**Response to RAIs**

**Highland Uranium Mine and Millsite**

**Request for Amendment to Radioactive Materials License UA-1139**

**April 8, 2013**

CLIENT	<b>ExxonMobil</b> Environmental Services				
PROJECT	<b>HIGHLAND MINE &amp; MILL SITE</b>				
TITLE	<b>LOCATION OF WELLS AND BORINGS USED IN THE MVS MODEL</b>				
<b>amec</b>		DRAWN BY	KMW	CHECKED BY	JW
		FILENAME	677520026	DATE	11/28/12
FIGURE No.					GE01-1

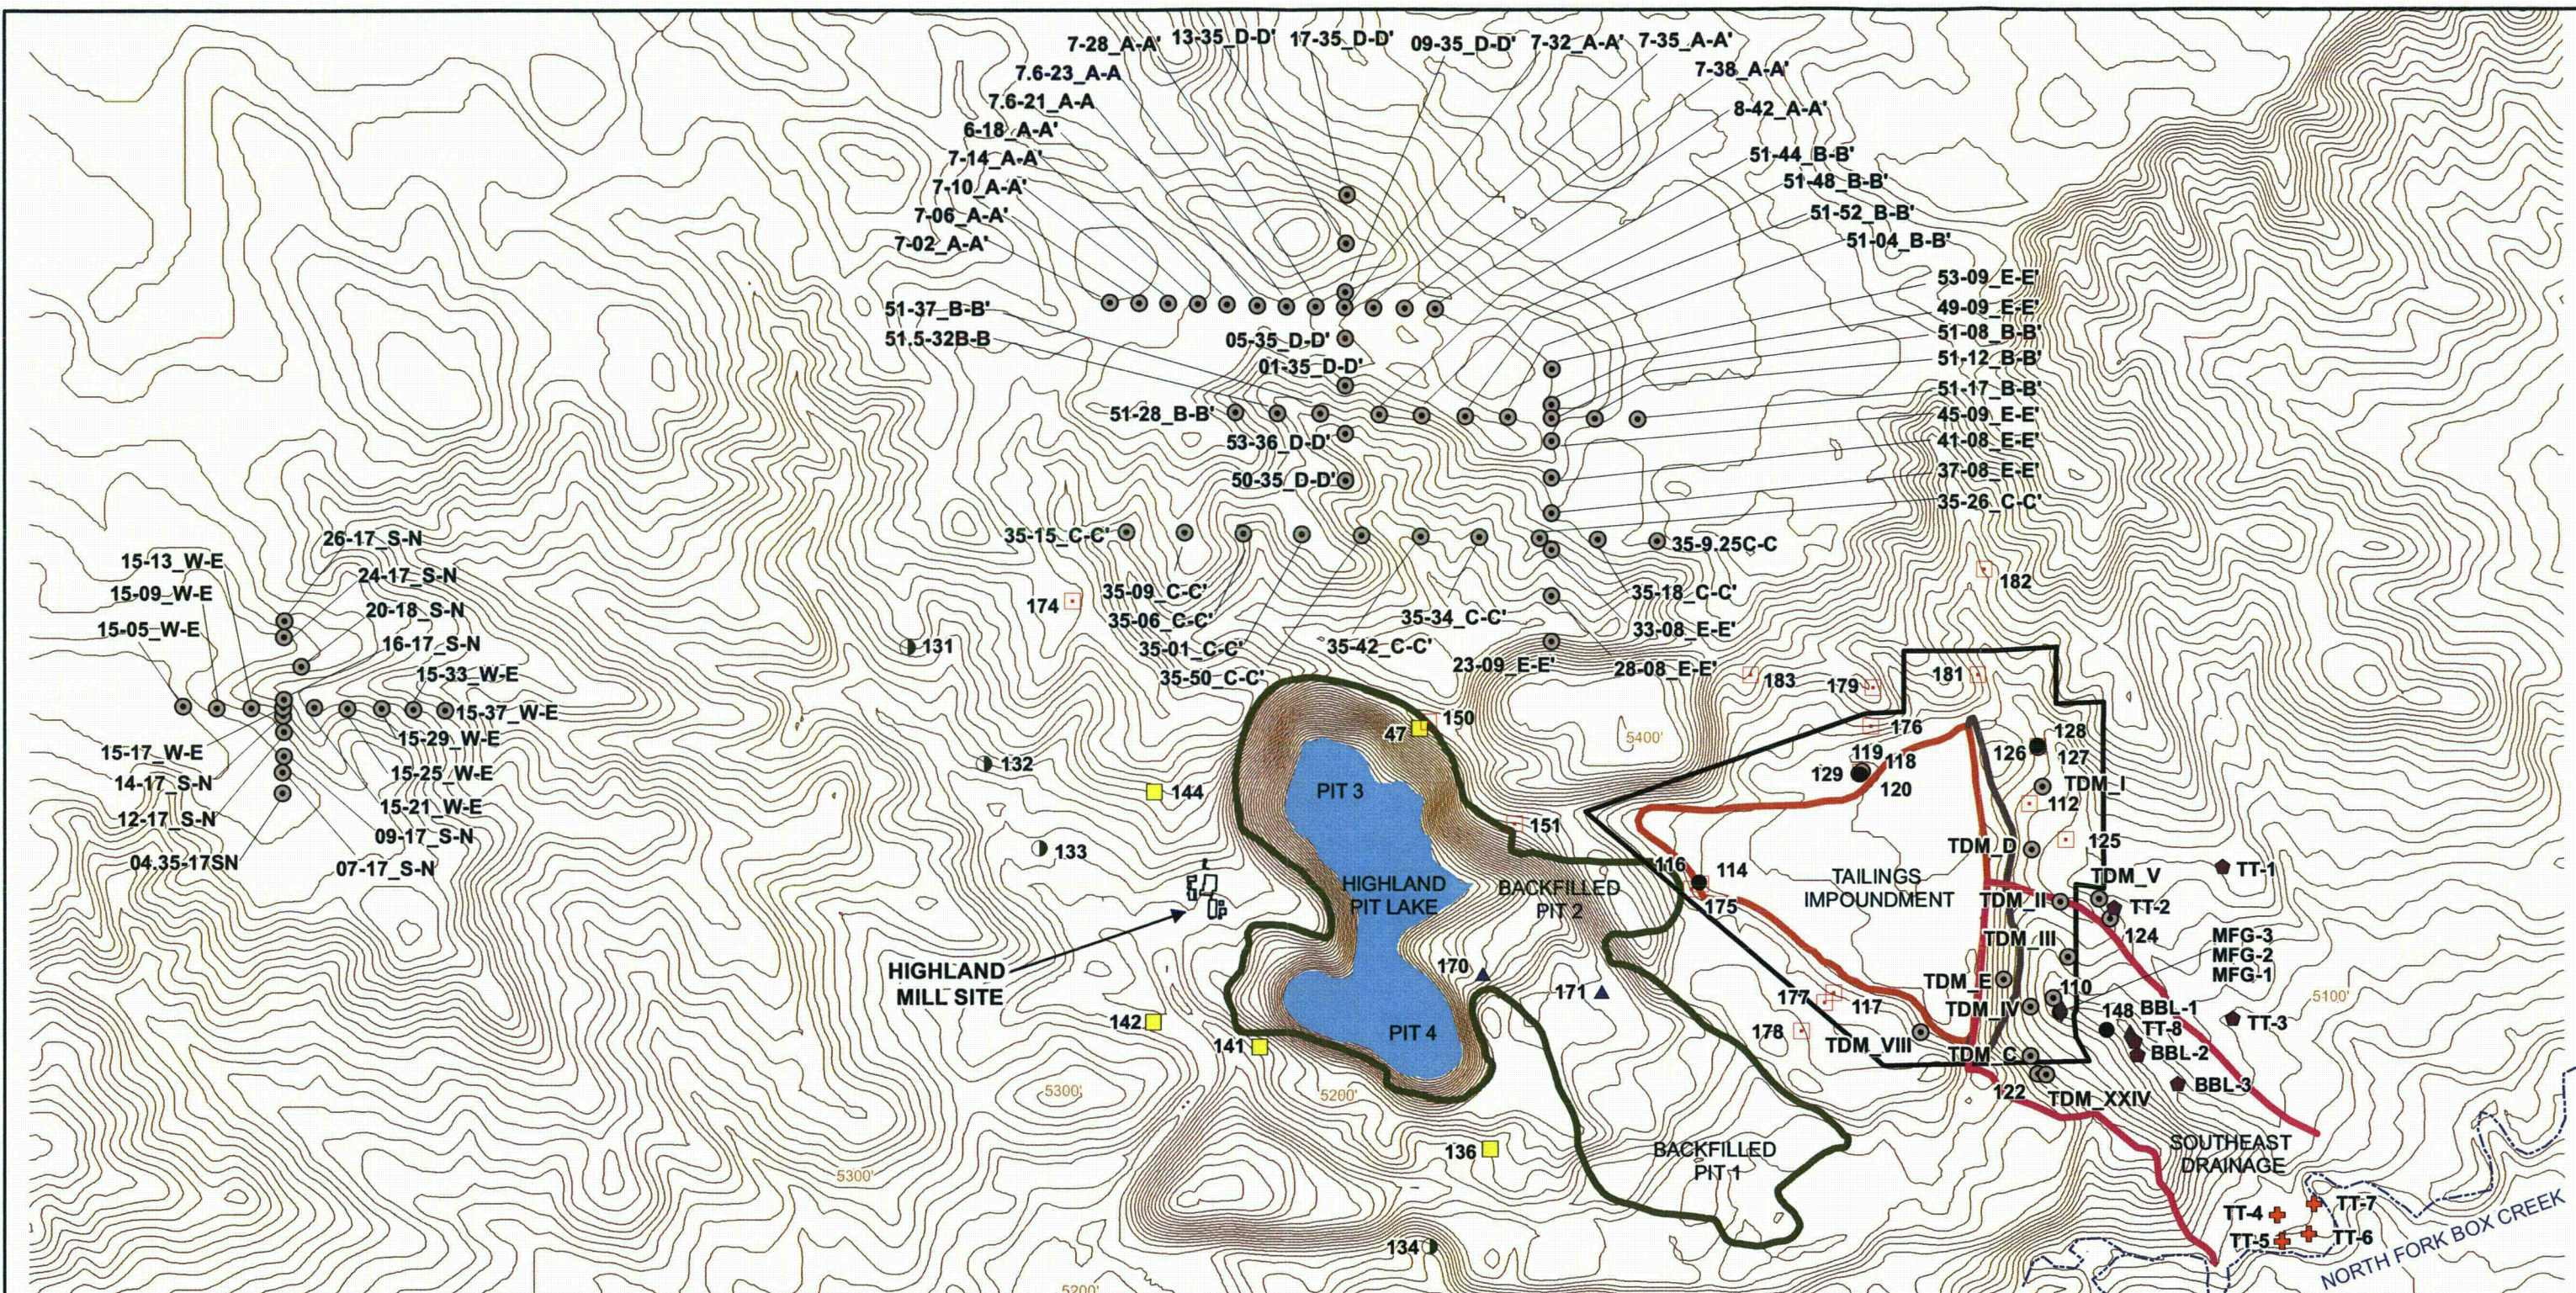
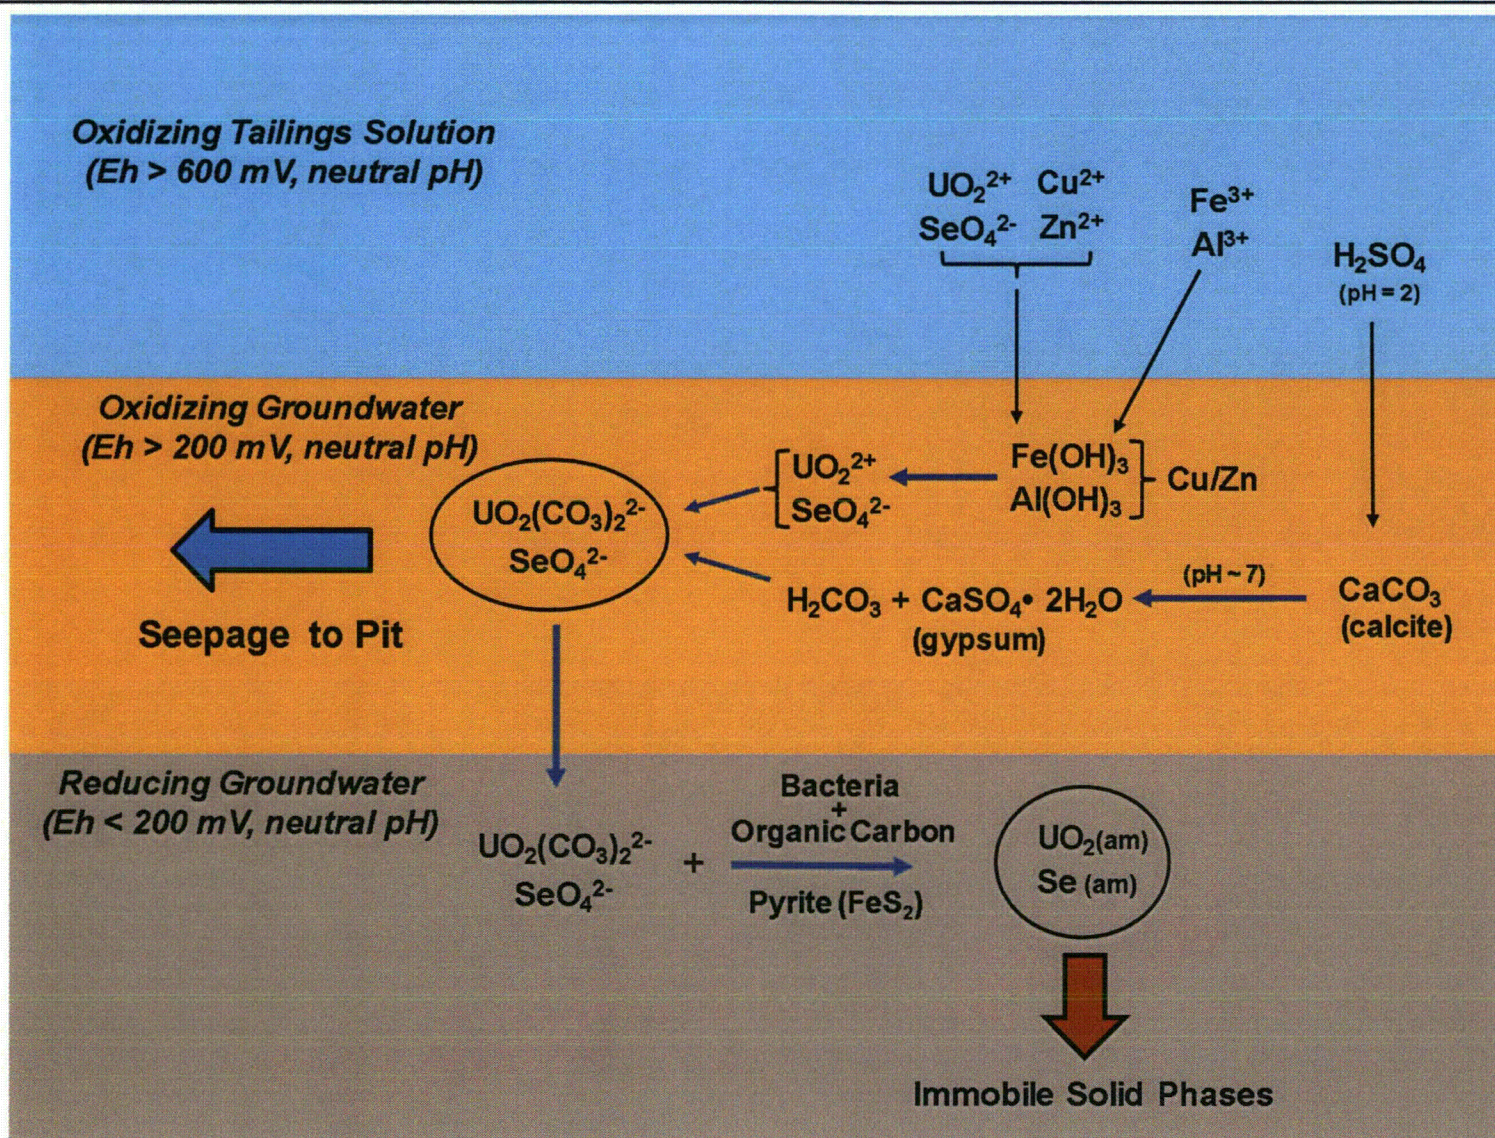
**NRC Staff RAI - Geo1** Provide additional information regarding the location of all “known” boreholes (wells and investigation boreholes) on the site and neighboring mine sites used to develop the geologic framework model discussed in the LAR (EMES 2011, Section 1.2.2.6). In addition, clarify whether the geologic framework model (EMES, 2011, Section 1.2.2.6) changed any previously assumed hydrostratigraphic conceptualizations that are used as inputs to other models. The licensee must also state whether the 3-dimensional (3D) geologic framework model provided any additional or new insights or a change in the understanding of the lateral extent and continuity of the strata in the LTSB. If so, these insights should be clearly described in the LAR. Additionally, the impact of these insights on the hydrogeological and geochemical processes should be discussed.

**RESPONSE:** Table Geo1-1 presents the primary data input to the geologic model. The geologic model requires estimates of the elevation of the bottom of each modeled stratigraphic unit, which were developed based on a review of available geologic logs for each boring. In some instances, previous interpretations of unit depths were used in the model. All geologic borings used to develop the model are shown on **Figure Geo1-1**.

FIGURE No. H15-2

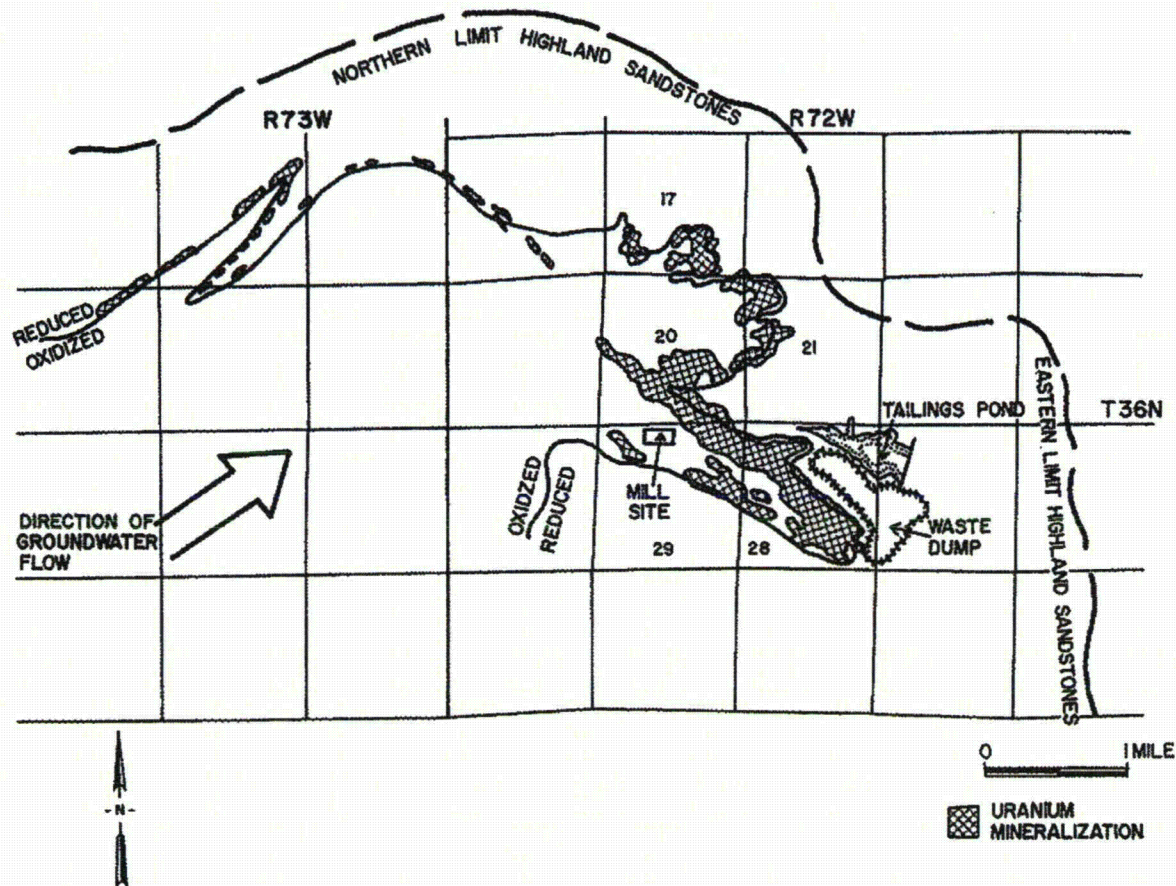
**NRC Staff RAI - H15 Provide technical justification for not evaluating a potential flow pathway north of the tailings dam.**

The technical justification for not fully evaluating a potential flow path to the north is based on historical publications and current data that indicate potentially-hazardous constituents (selenium and uranium) are unlikely to be transported to the north due to prevailing redox conditions to the north. The conceptual geochemical site model discussed in Section 1.3 of the LAR and shown schematically in **Figure H15-1**, indicates limited transport of these elements under reducing conditions due to the formation of solid phase precipitates. Early investigations of the Highland sandstone units and the roll-front deposits found reducing conditions to the north of the tailings impoundment as shown in **Figure H15-2**. Chemical data from monitoring wells on the Site, including dissolved iron support the findings of these early investigators and the geochemical

FIGURE No. GC-3-1

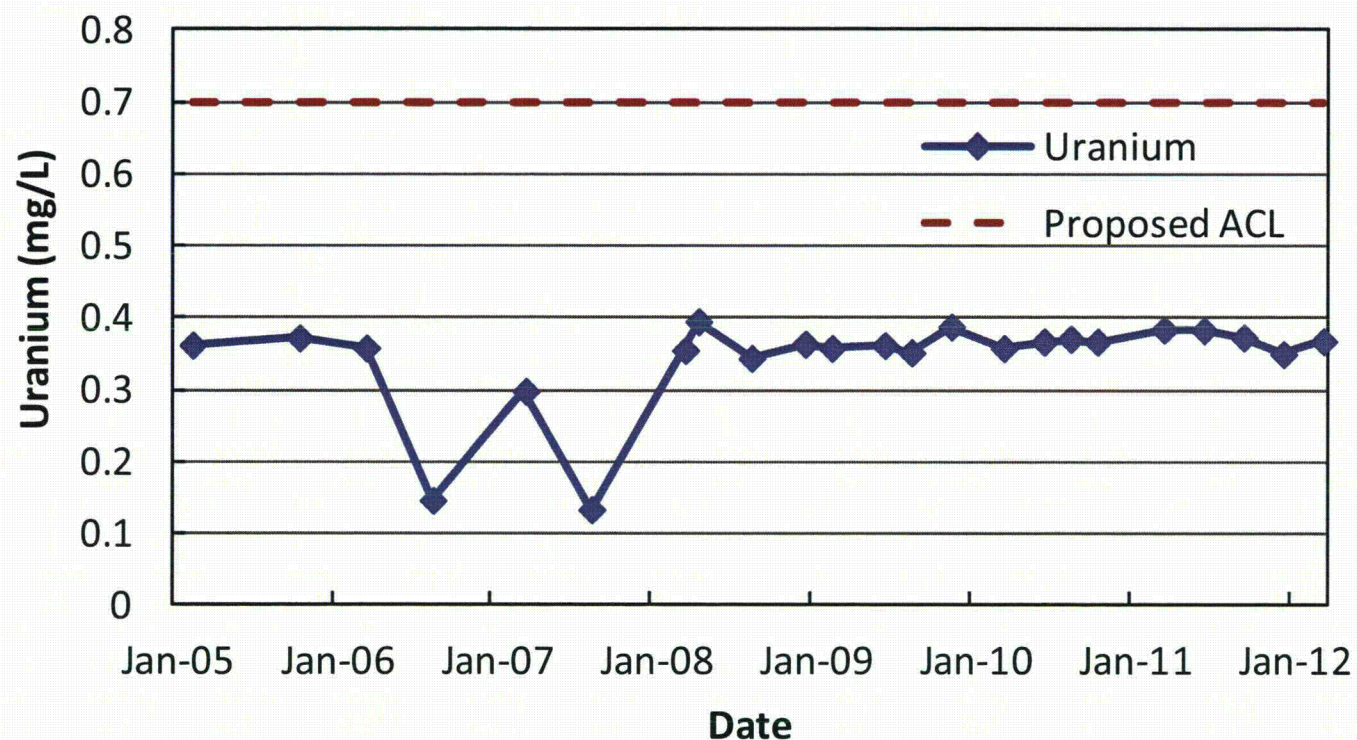
**NRC Staff RAI - GC-3: Provide the technical bases for the statement “Groundwater uranium concentrations at Well MFG-1... are not anticipated to increase as tailings seepage rates continue to decline (Section 2.2.3.2)” (EMES, 2011, p. 4-4).**

The trend-plot for uranium at MFG-1 has been updated to include all data through the first quarter of 2012 and is presented on **Figure GC-3-1**. The data show that in 2006 and 2007, there were large downward fluctuations in uranium concentration compared to initial concentrations, but uranium never increased during this period. Since 2008, uranium concentrations at MFG-1 have remained fairly stable between 0.344 mg/L and 0.395 mg/L and do not appear to be increasing or decreasing (**Figure GC-3-1**).

FIGURE No. GC-4-1

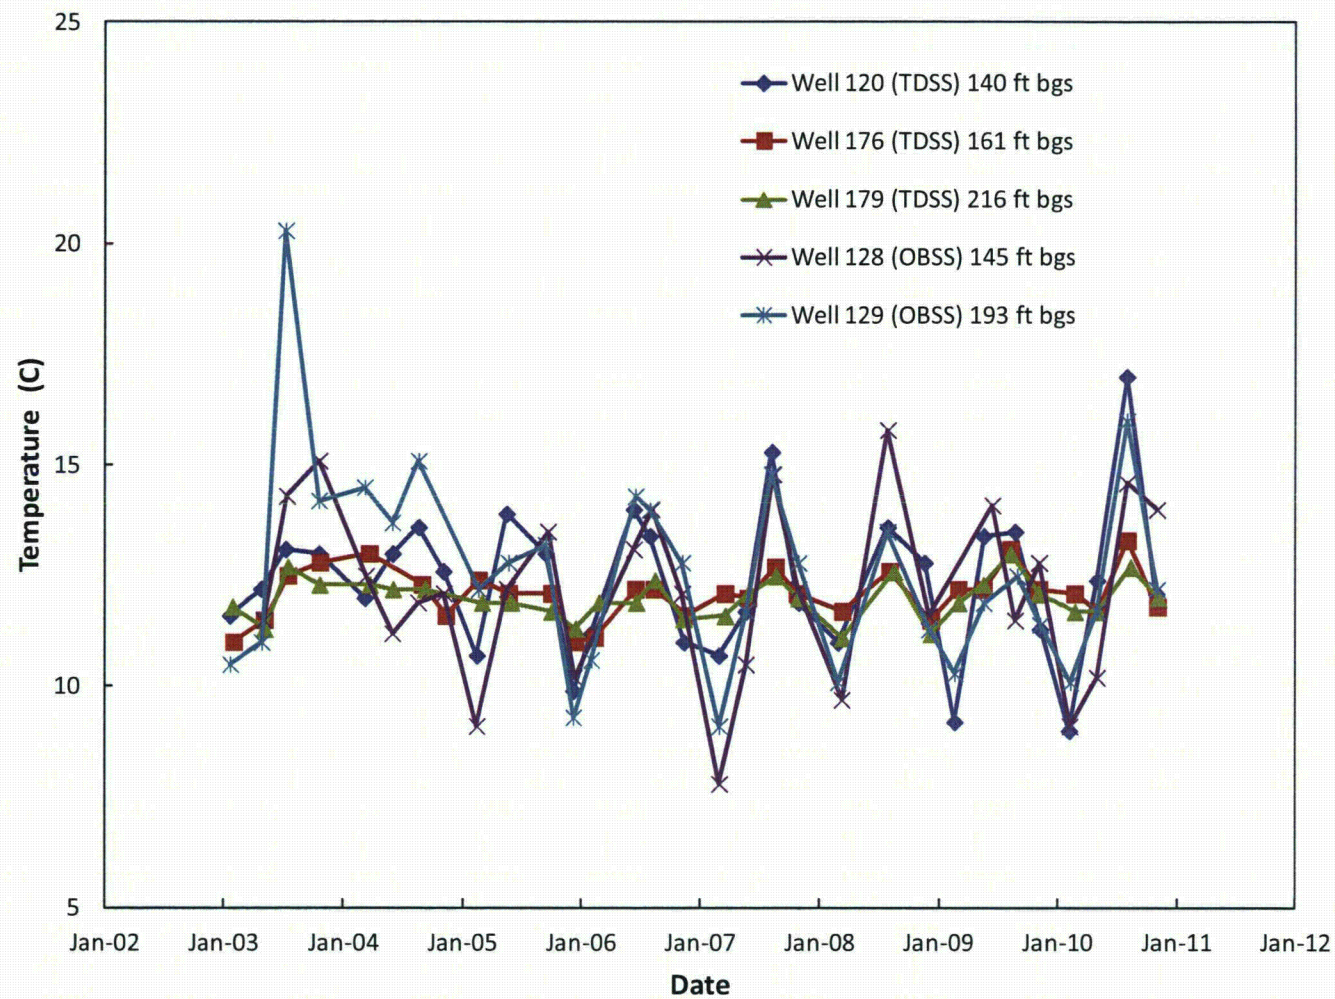
**NRC Staff RAI - GC-4: Provide the technical bases for the variations in water temperature and solute concentrations reported in data for Wells 129 and 128.**

The historic temperature data through 2010 for OBSS Wells 128 & 129 and nearby TDSS Wells 120, 176, and 179 are shown on **Figure GC-4-1**. The larger seasonal temperature variations in OBSS Wells 128 & 129 and TDSS Well 120 compared to TDSS Wells 176 & 179 are apparent. Groundwater temperatures are lower in winter and warmer in summer in all wells (**Figure GC-4-1**), which is consistent with seasonal warming and cooling at the surface. The exchange of heat between the sun, earth, and atmosphere ultimately controls the temperature of the earth's surface and shallow groundwater. In shallow groundwater, seasonal variations related to surface temperatures can be on the order of 5 to 10°C or more (Nelson, 2002). In groundwater deeper than 50 to 75 feet, however, seasonal changes are generally less than 1°C (Heath, 1989).

FIGURE No. HAZ1-1

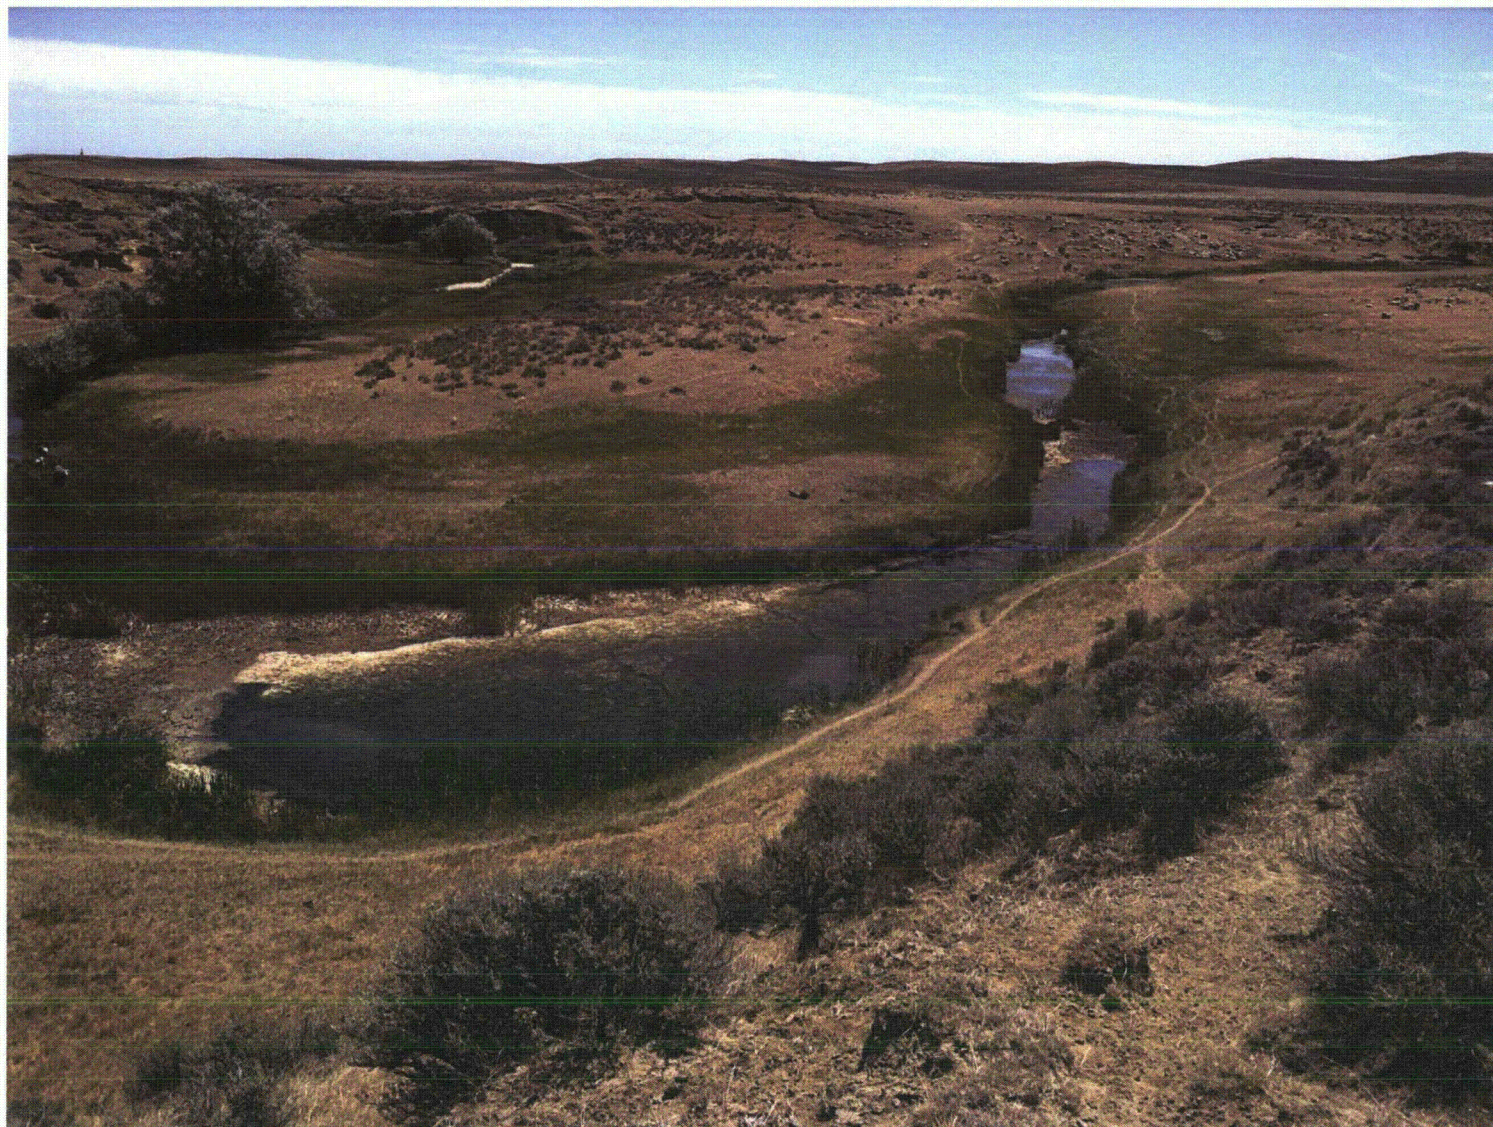
**NRC Staff RAI - HAZ1: Provide the bases for the characterization of the alluvial floodplain as ephemeral and that water quality is affected by biological fouling by giardia and fecal coliform bacteria.**

**RESPONSE:** The bases for characterizing the alluvial floodplain along North Fork Box Creek (NFBC) as ephemeral and that water quality is affected by biological fouling is based on knowledge of the site and surface water data collected over the last several years. The NFBC flows as a continuous stream only during a very short time, if at all, during the spring runoff. At other times of the year the only water in NFBC is found in isolated pools as seen in **Figure HAZ-1-1**.
